# Technical Bulletin

Section Title: Engine  
TSB No. TS 21 03259

**SUBJECT:** RUBBING NOISE COMING FROM FRONT (TIMING BELT COVER) AREA OF ENGINE  
**MODEL(S):** FORENZA, FORENZA WAGON, RENO (RQ420)  
**YEAR:** 2004~2008

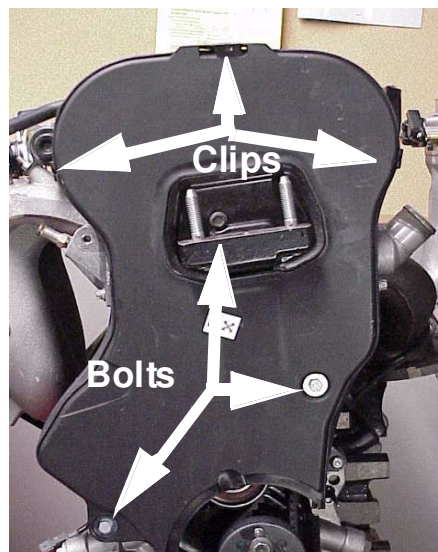
9. Referring to the illustration, remove the timing belt cover by releasing the three clips at the top of the cover. Next remove the three bolts indicated. Tip the cover toward the fender to clear the engine mount bracket, and slide the cover up and out.

10. Looking closely at the area indicated in the illustration, inspect the timing cover for contact marks from the timing belt or cam sprockets. If evidence is found confirming the source of the noise, continue to the next page.

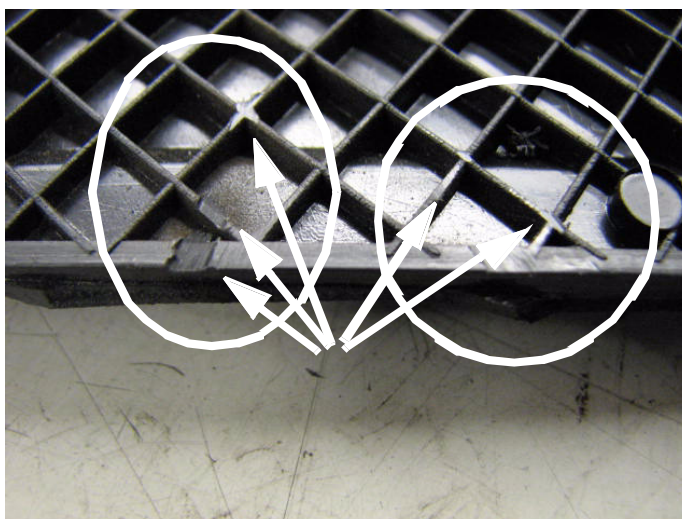
11. Mark the area with a wax pencil, white out, or anything that will be highly visible.

12. Use a high speed grinder to carefully remove 2mm of material from all the affected areas of the timing cover.
13. Reverse the removal procedure of the timing cover. Torque specs are highlighted in the table below.
14. Reconnect the battery, and if necessary reprogram the radio presets.
